**Imperial Oil Resources N.W.T. Limited (Imperial)**  
**Application for Variance of Operations Authorization 1210-001**  
**Application for Line 490 Replacement Activities**  
**Subsection 5(6) of the Canada Oil and Gas Operations Act (COGOA)**

**File 3430830 and 5612618**

**Information Request No. 4**

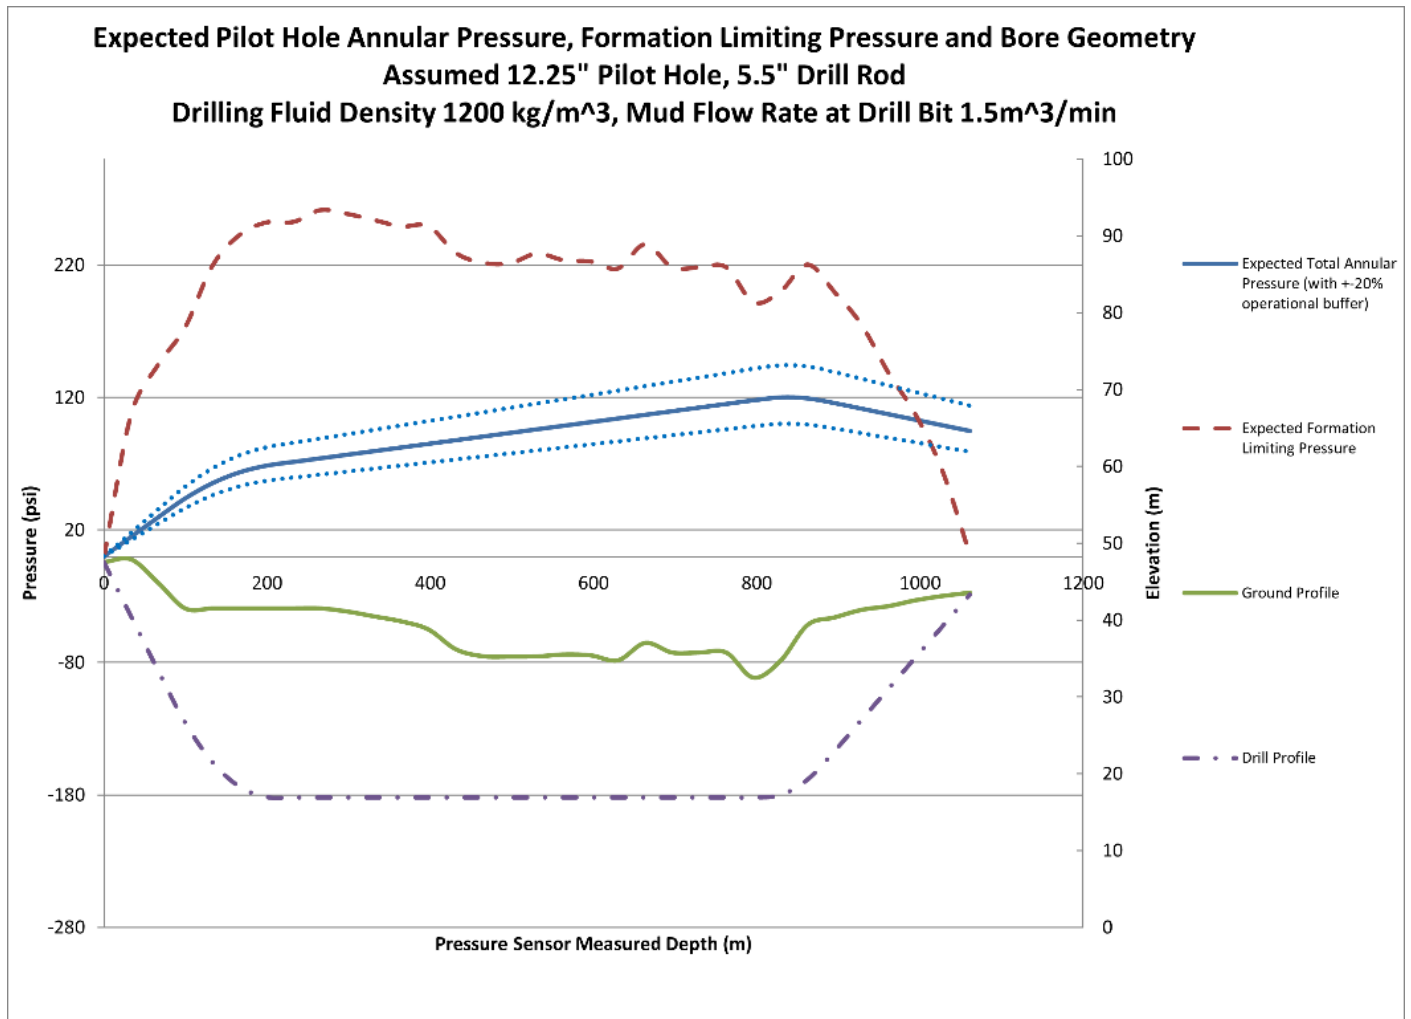
A feasibility study should include a chart that shows the annular pressure calculation, the required drilling fluid pressure, the total overburden stress, the operating limits and the drill path elevation and the ground profile along the HDD chainage. This chart was not included in the submitted feasibility study and would aid in the HDD frac-out risk assessment.

- a) the chart that shows the calculated annular pressure, the required drilling fluid pressure, the total overburden stress, the operating limits, the drill path elevation and the ground profile along the HDD chainage; and
- b) a discussion of the risks associated with frac-out and HDD construction operation based on the data in the chart.

- a) A preliminary annular pressure chart is provided below. It will be updated following any geotechnical field program as well as with input from the HDD Contractor's execution plan.

Soil properties are based on typical values for medium sand and/or stiff clay.

- b) As modelled, the minimum factor of safety (formation limiting pressure divided by expected drilling annular pressure) through the river is 1.63 near the site of the pipe exposure. Typically, the formation limiting pressure decreases as the drill nears the exit point. The factor of safety drops below 1.5, approximately 125 m from the exit (on Goose Island.) The factor of safety drops below 1.0 approximately 60 m from the exit. The risks associated with inadvertent returns of drilling fluid (frac-out) under the river are considered low. The exit angle of 7° is relatively shallow, and risks associated with inadvertent returns of drilling fluid near the exit can be mitigated by reducing drilling pressure and volumes as the drill profile nears the exit point.

Figure 3.10 Pipeline rupture flowchart

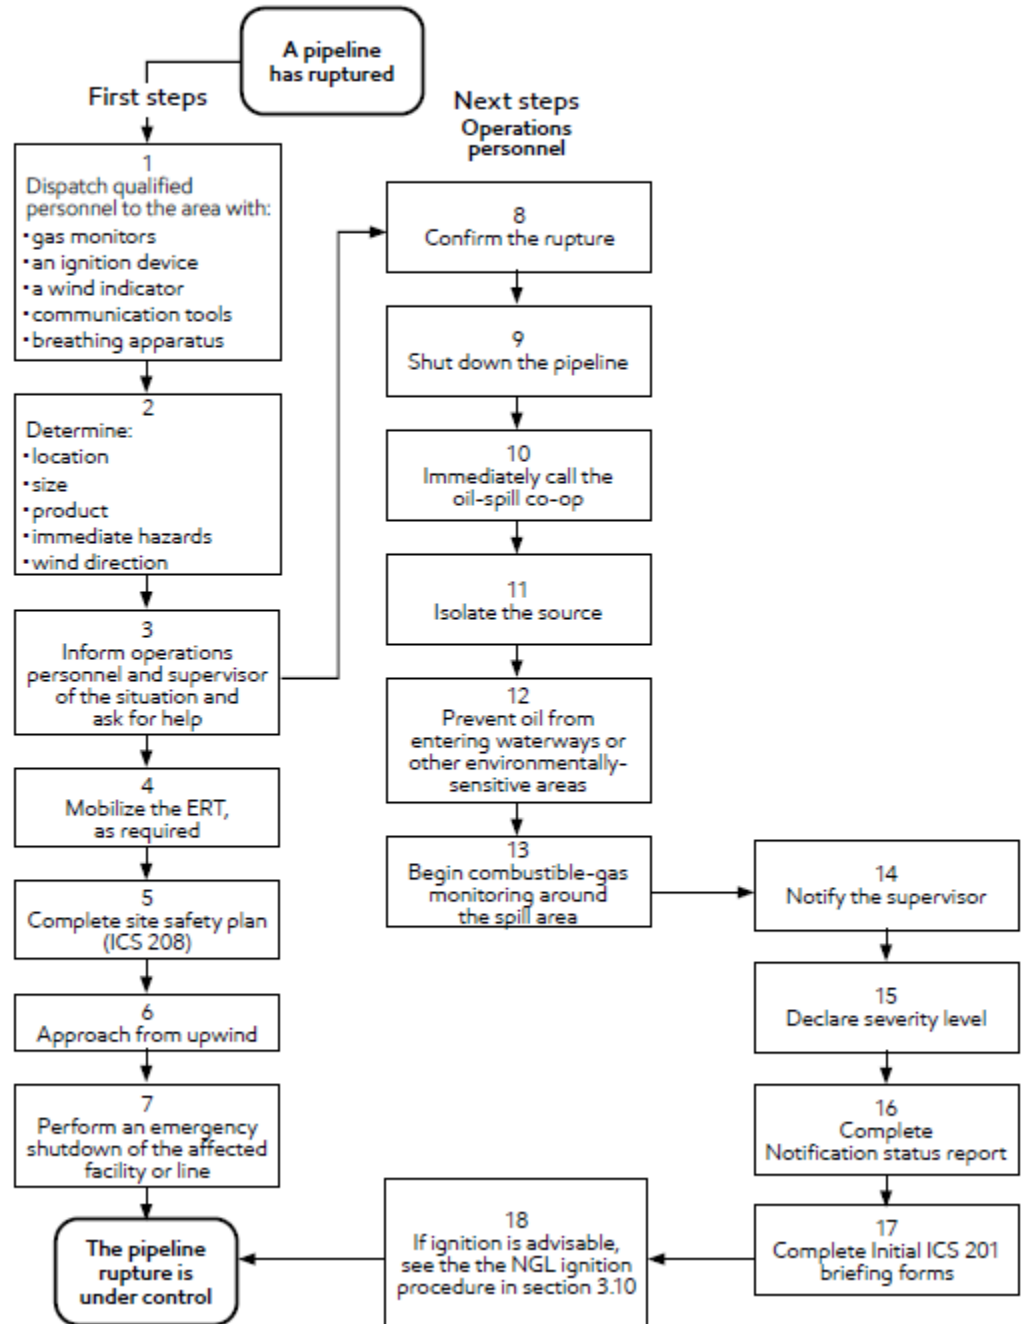
Explain Imperial's strategy for downstream protection of sensitive shorelines and product recovery, in a worst-case scenario, within the first 24 hours and within the first 48 hours.

When read together as intended, the plans describe the variables that must be taken into consideration for releases in different seasons and points of origin whether the volume is minimal or a worst-case scenario. Within the first 24-48 hours, these plans would be used together to formulate a response. Regarding the scenario of a spill from a flowline in open water,

the NWO ERP Figure 3.10 outlines the initial steps that would be taken. This figure is reproduced below for ease of review.

The Emergency Response plans describe the approach, planned steps, necessary considerations, and existing conditions relevant to shoreline protection (the strategies and tactics). Summarizing the approach for a spill of any size, the priorities progress from the safety of people in the immediate area, notifications within the emergency chain of command (including notification of applicable regulatory authorities and potentially
